AMENDMENT OF SOLICITATION/MODIFICATION OF CONTRACT

Item 14. Continued.

5. Attachment E - Drawings.- Replace the drawings listed below with the attached new drawings of the same number, bearing the notation "AM #0004":

C101.cal C101 Site Plan
A101.cal A101 Floor Plan
E101.cal E101 Data/Communications Plan

FUNCTIONAL REQUIREMENTS

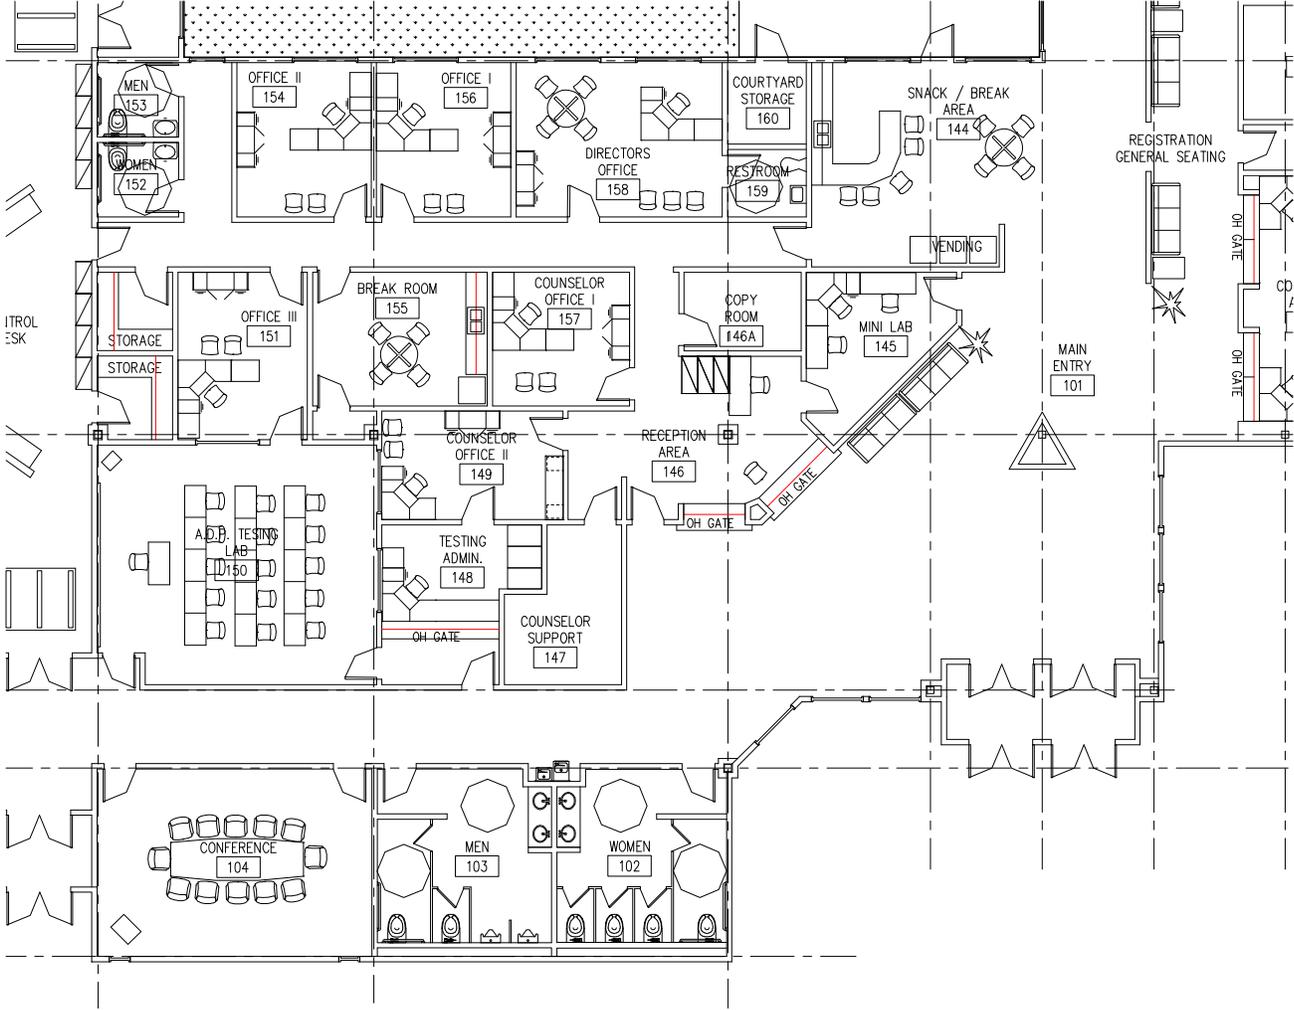
Amendment 0004

FUNCTIONAL REQUIREMENTS

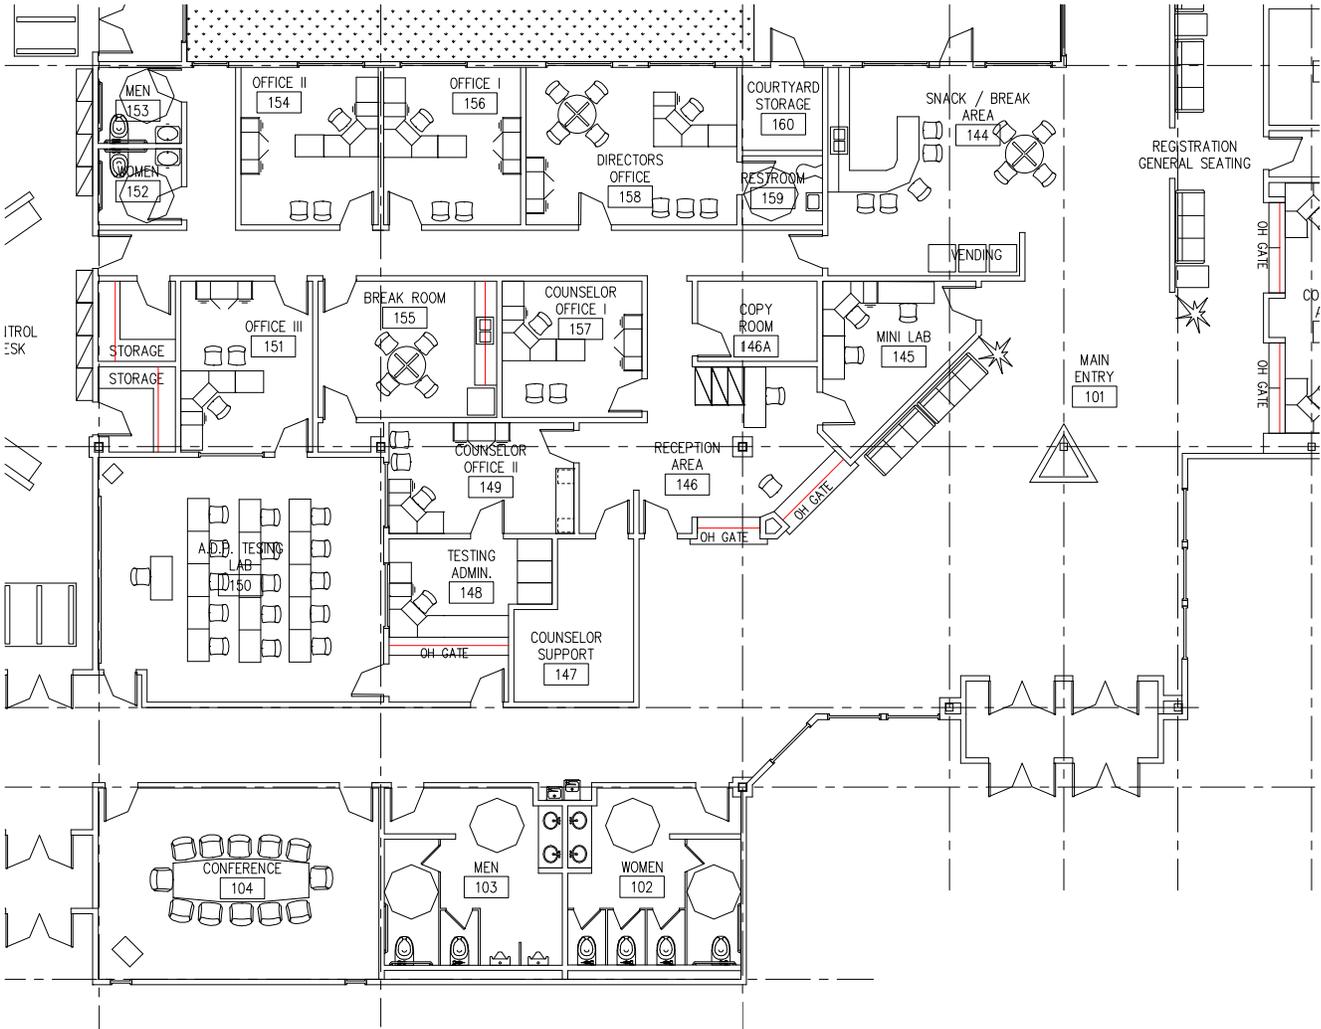
Amendment 0004

FUNCTIONAL REQUIREMENTS

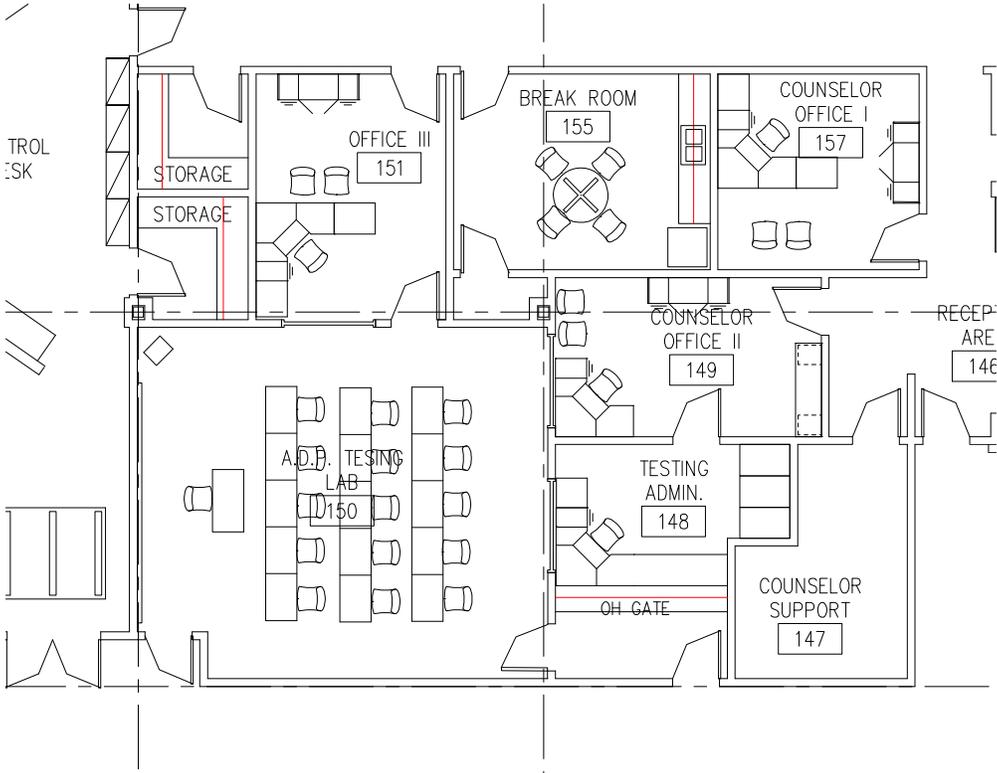
Amendment 0004

FUNCTIONAL REQUIREMENTS

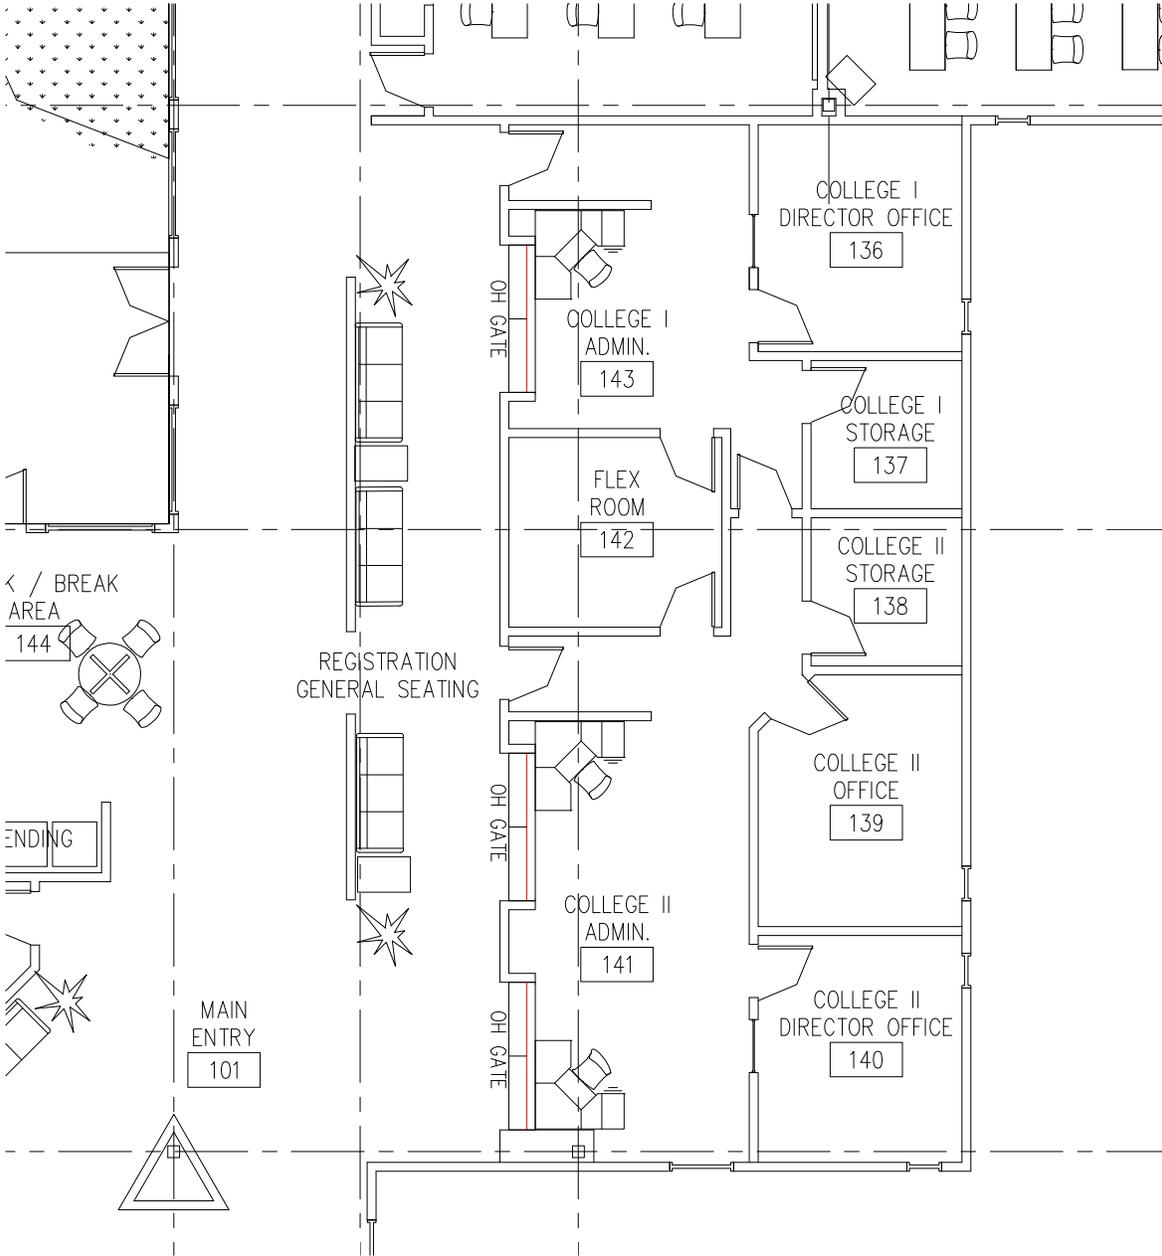
Amendment 0004

FUNCTIONAL REQUIREMENTS

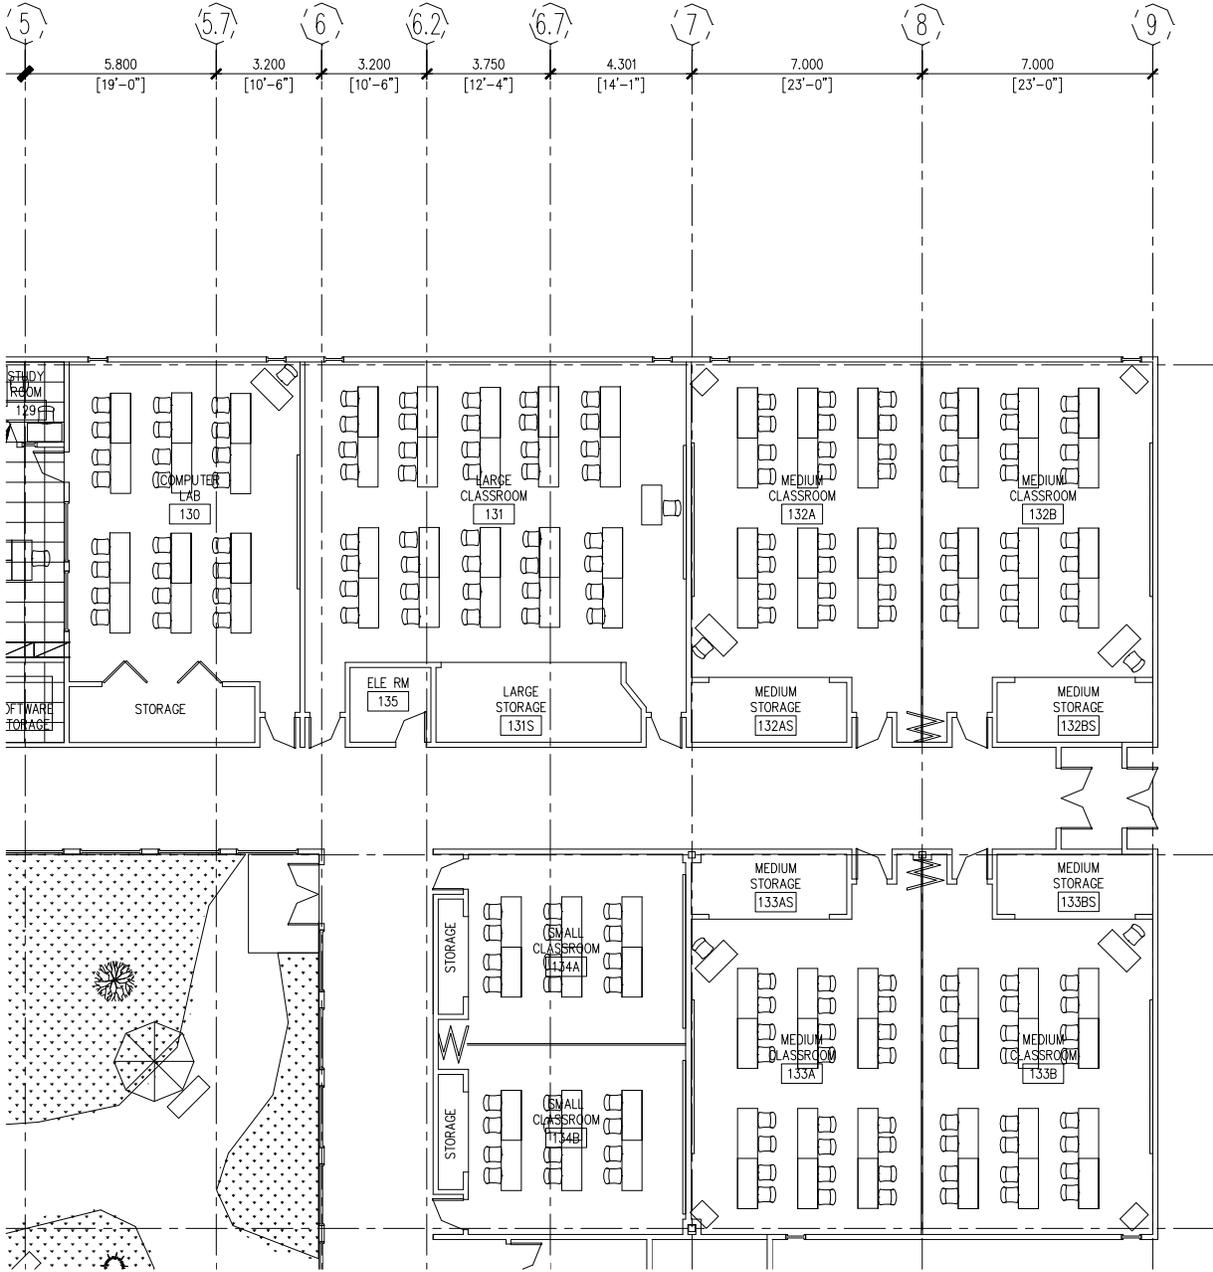
Amendment 0004

FUNCTIONAL REQUIREMENTS

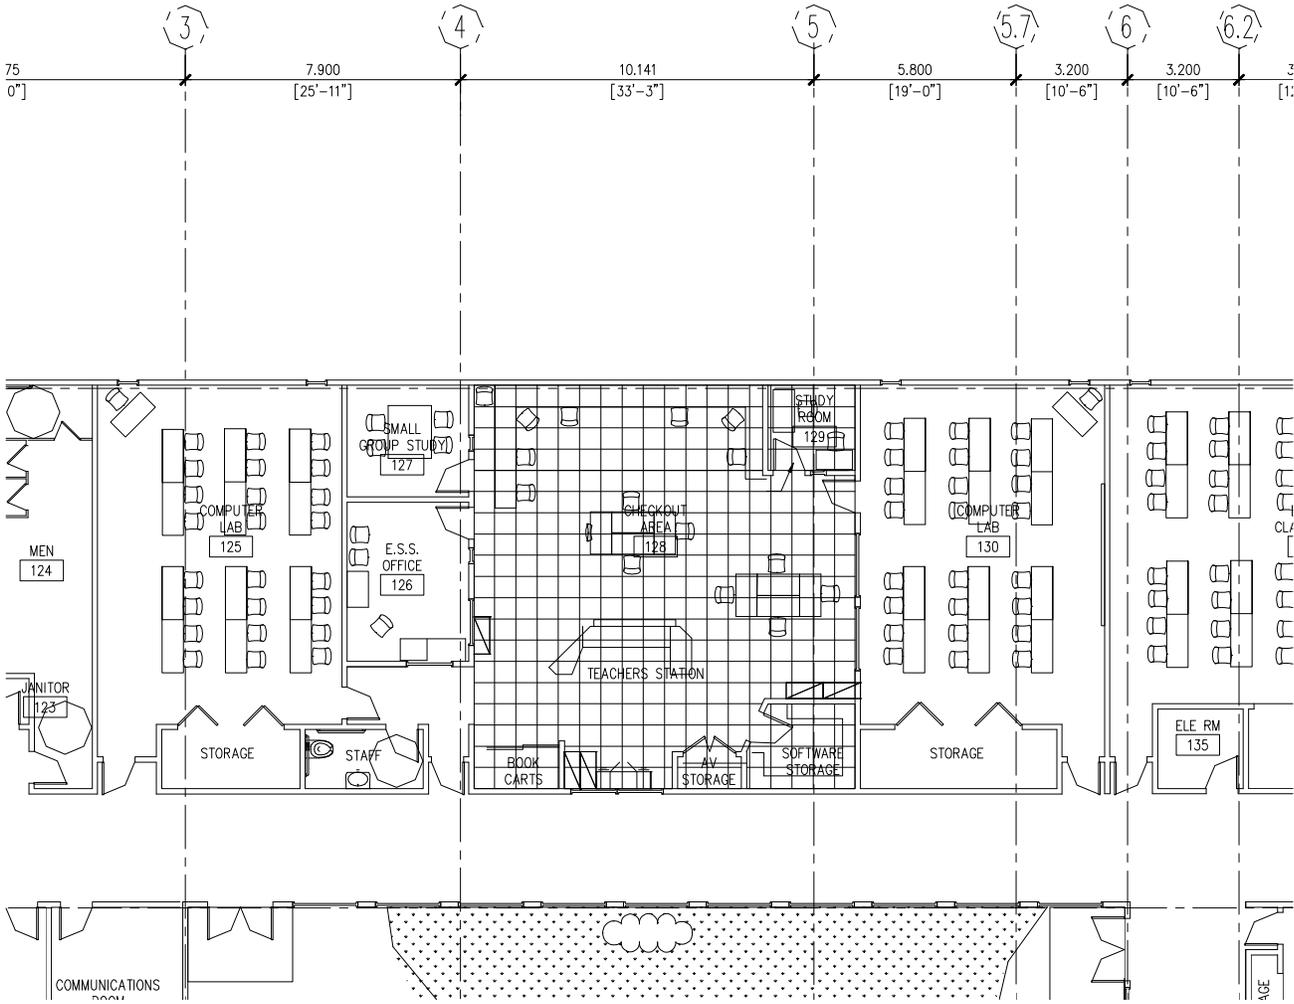
Amendment 0004

FUNCTIONAL REQUIREMENTS

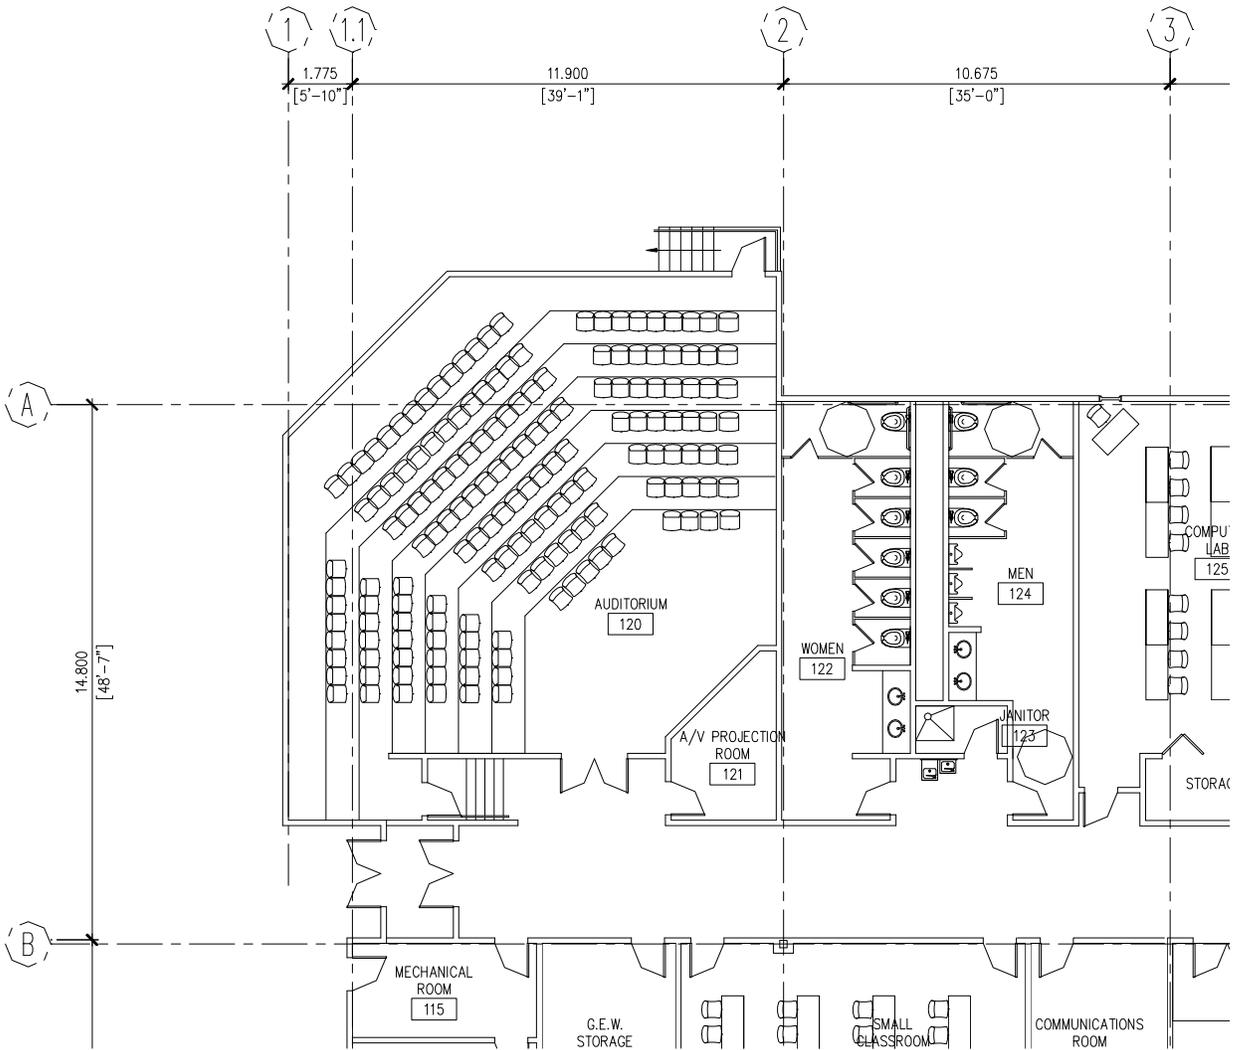
Amendment 0004

FUNCTIONAL REQUIREMENTS

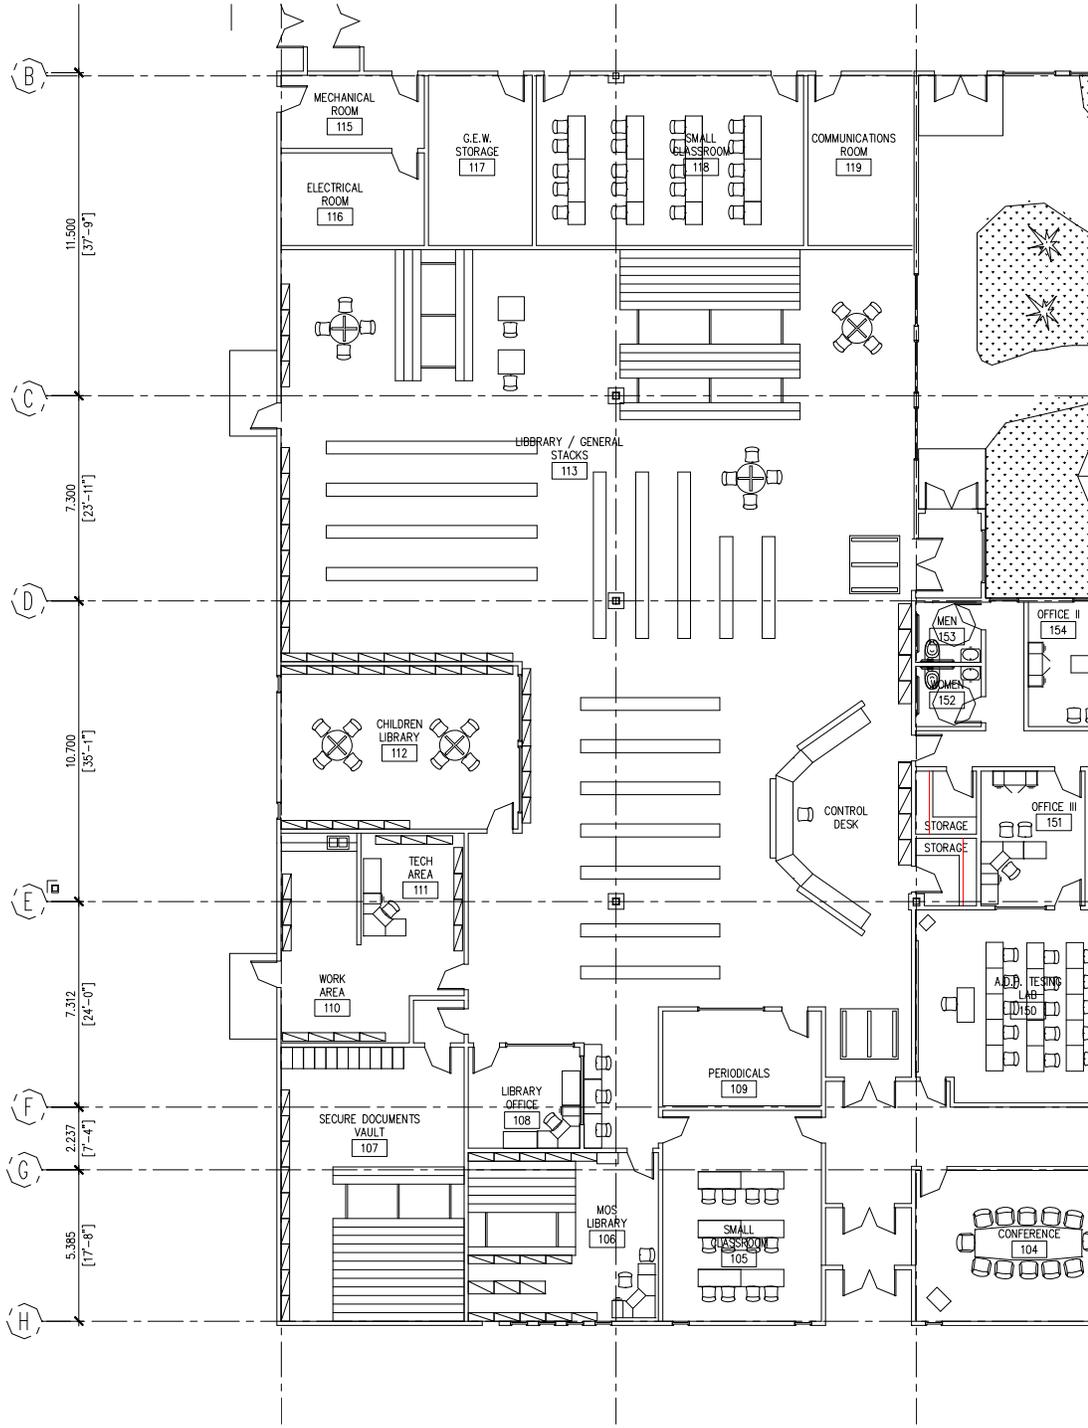
Amendment 0004

FUNCTIONAL REQUIREMENTS

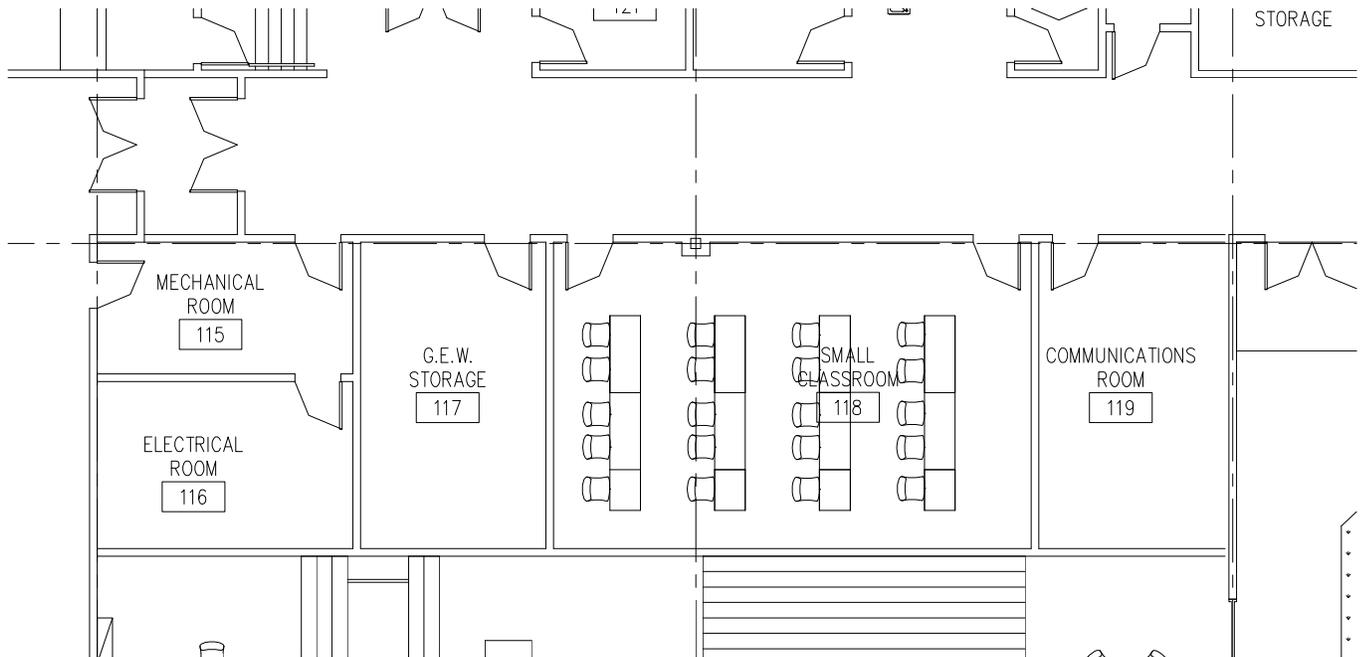
Amendment 0004
